**Addendum #1 Raytown Concrete**

**Location- Admin Building 6608 Raytown Rd**

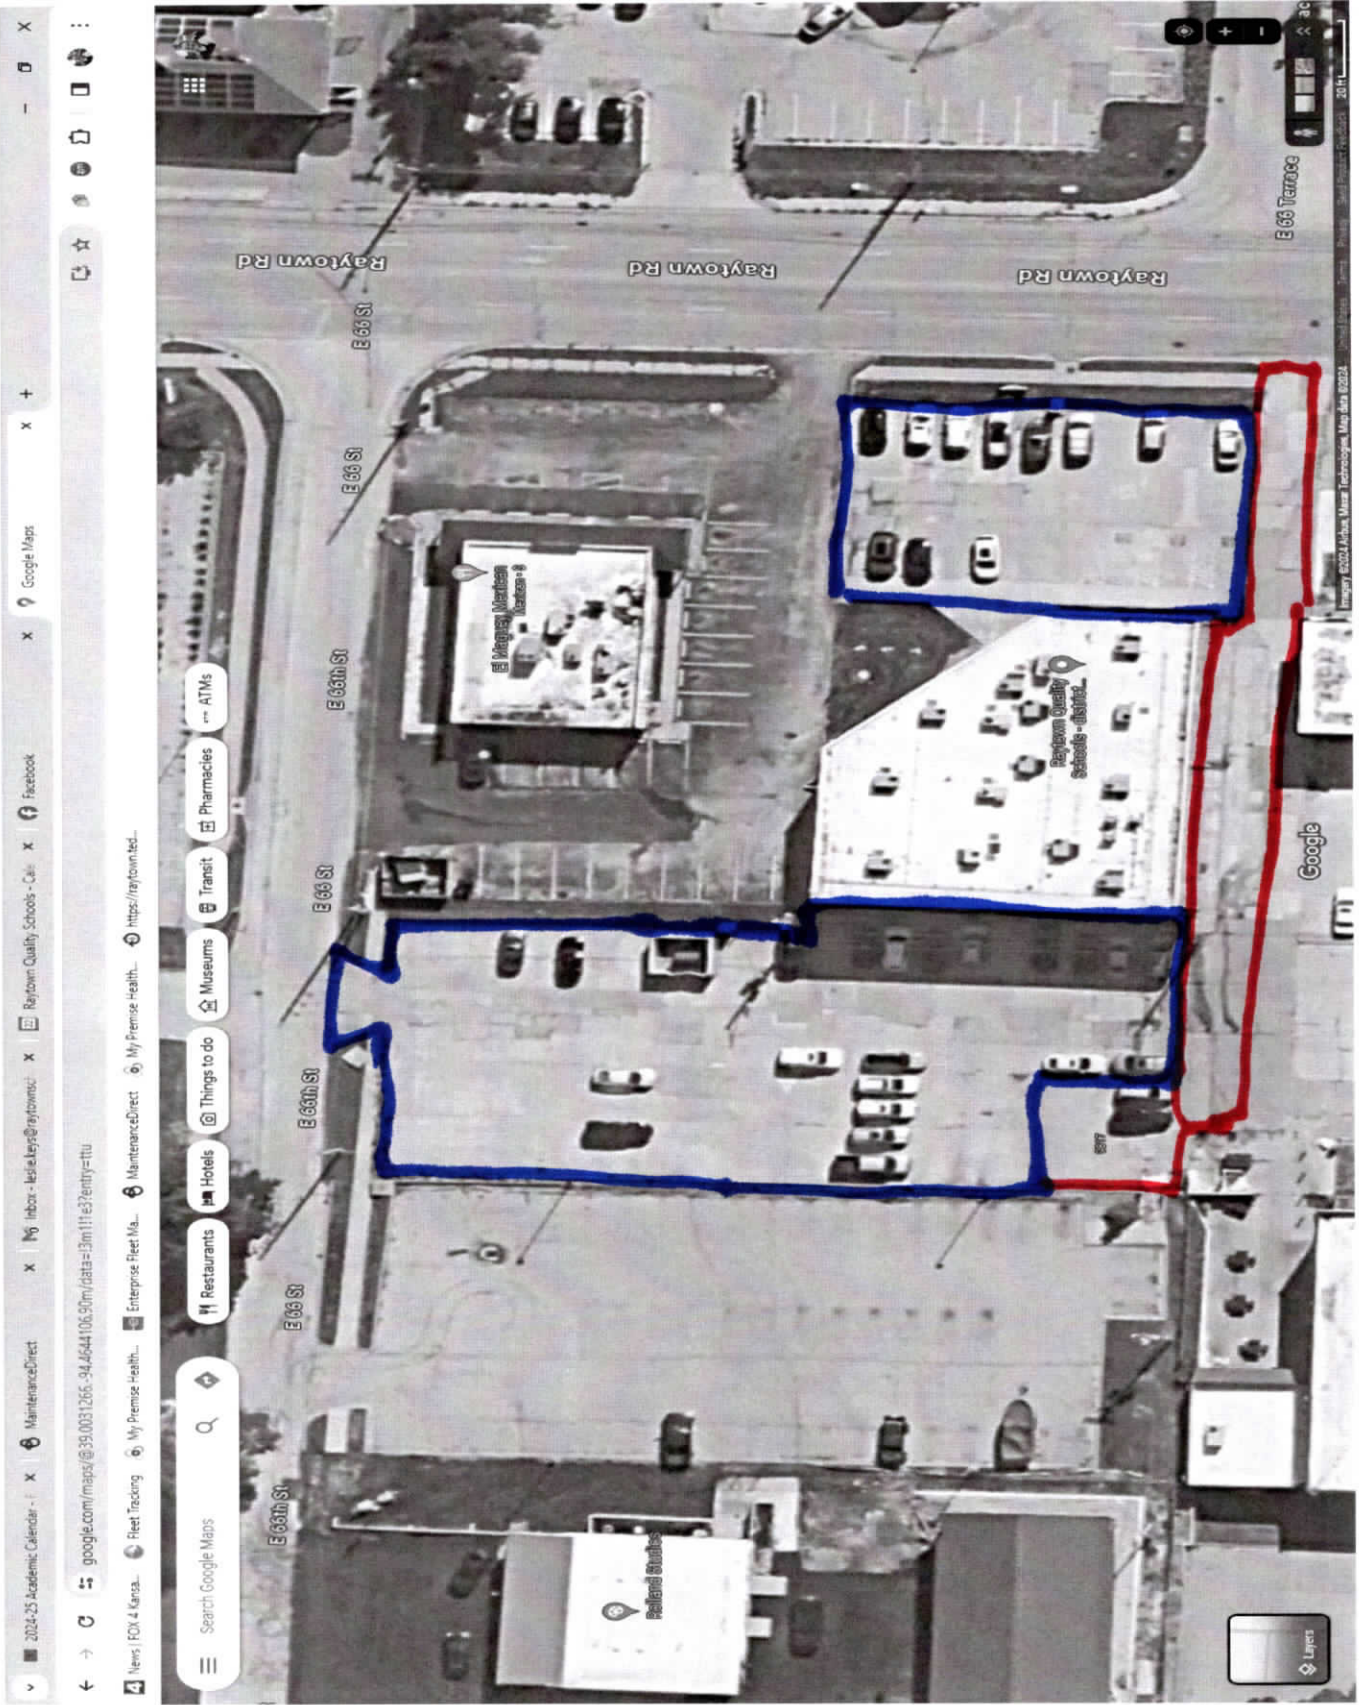
1st + 1A - [red square]  
[blue square] - [blue square]

**Blue - Base Bid**  
**Red - Alt #1**

**See attached for Alt 1 area**

**4" of clean gravel**

**5" of 4000 psi Concrete**

**Parking lot striped as indicated by owner**

**Disposal of existing concrete by contractor**

**Provide a sqft price to remove and replace concrete to the above specs.**
